<b>Title: Cavalon Tank Cap O-Ring Replacement</b>		
<b>AG-SB-2019-03-B-EN</b>		<b>Compliance Category:</b>
<b>Applicability</b>		<b>A – MANDATORY</b> <b>B – RECOMMENDED</b> <del><b>C – OPTIONAL</b></del>
<b>Aircraft type &amp; model:</b>  Cavalon	<b>Affected Serial number(s):</b>  All Cavalon from V00367 to V00429, excluding V00418, V00426, V00428	
The maintenance manual to be referenced is this stated or subsequent issue.		As per AutoGyro website
<p>This form is the response from AutoGyro GmbH either against a problem found in the product in service requiring a containment or rectification action, or as service information for aircraft modification incorporation.                  For help, contact AutoGyro on 49(0)5121 88056-00, or email <a href="mailto:airworthiness@auto-gyro.com">airworthiness@auto-gyro.com</a>.</p>

**Reason and overview of the Service Bulletin (cause of problem if known)**

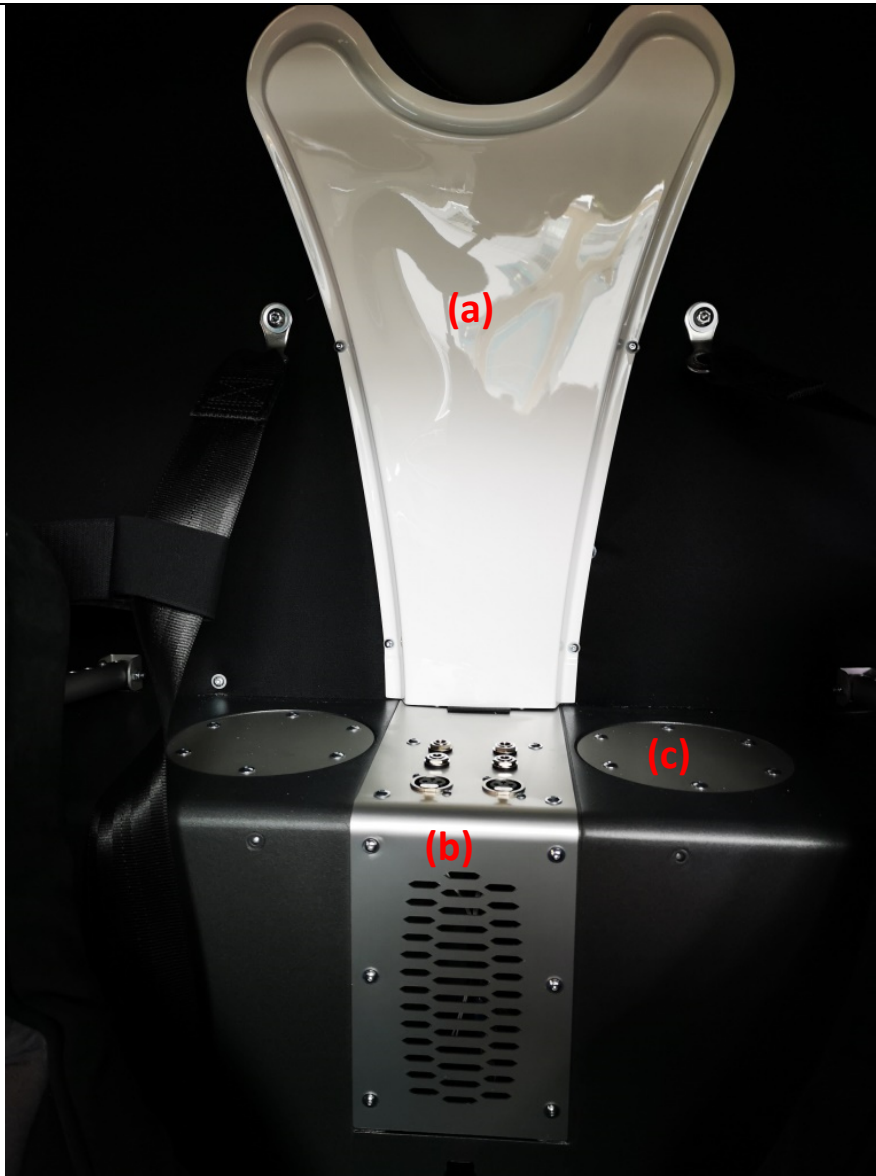
The recent modification of the Cavalon tank introduced a tank filler cap assembly that is sealed at the tank by an o-ring, and secured in position by an M50 PA nut (f) (drawing below)

Due to small variations in tank wall thickness, it is possible that the current o-ring (g) may not sufficiently seal the assembly. A thicker o-ring measuring 50x5mm has been introduced.

11. Clean all old sealant and any fluids from all tank components (d,e,f,g & h) and tank surfaces.
12. De-grease all components stated in operation 10.
13. Place the new o-ring 44557 50x5 onto the tank cap.

Interior – PPC cover (a), intercom panel (b) & Tank access covers (c)

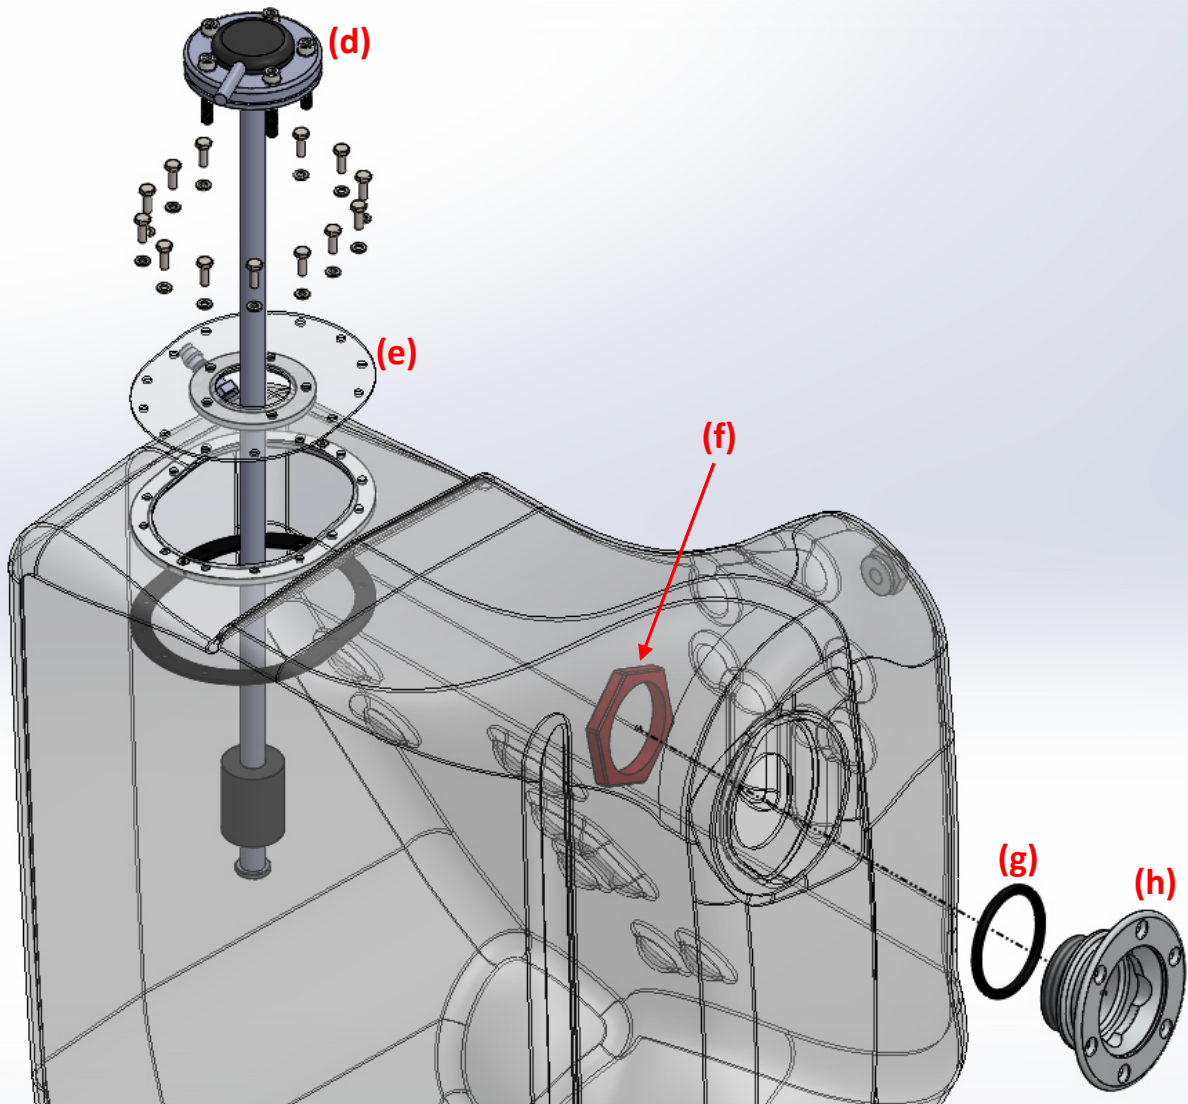
1. Drain the tanks of fuel.
2. Remove the PPC cover (a) in the cabin interior to gain access to the two rear screws of the intercom panel (b).
3. Remove the intercom panel (b) to gain access to the tank level sensor plug (photo).

4. Remove the left tank access cover (c) to gain access to the tank level sensor (d).
5. Disconnect the blue 9 pin plug of the tank level sensor and, noting the location of the wires in the plug, remove the two wires using tool 27403.

6. Remove the six screws of the tank level sensor (d) and, noting orientation, remove the sensor. Secure the ground cable to the tank upper surface with tape.

7. Remove the 14 bolts of the cover plate (e) and remove the cover plate to gain access to the M50 PA nut securing the tank cap (f).
8. Using a 60mm socket (46505), remove the M50 PA nut (f) on the rear of the tank cap (h). The ratchet can be inserted into the socket in a reverse manner from outside the aircraft to ease disassembly and assembly.

14. Re-assemble the tank cap and the tank level sensor in reverse order to disassembly (M50 nut torque 30 Nm), ensuring Loctite 5331 is re-applied to the respective surfaces and screws of cover plate (e) & tank level sensor (d).
